XT30/XT50 Series Control Panels

April 2017

Hardware Update

Figure 1: XT Series Panel with a Cell Pin Header Shroud

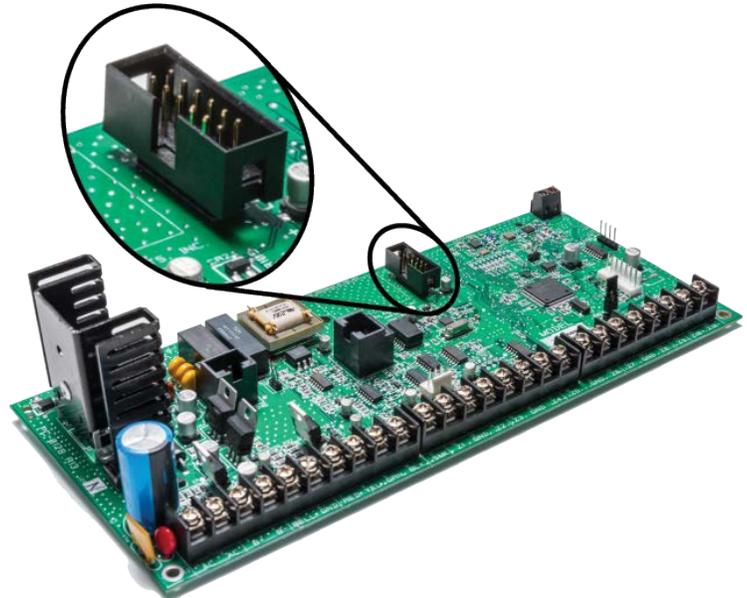
Cell Pin Header Shroud

XT30/XT50 Series panels now have a built-on plastic shroud around the cell pin header. This plastic shroud prevents the pins from vertically misaligning when a cellular communicator is installed. Misaligning pins can cause damage to both the panel and the cellular communicator.
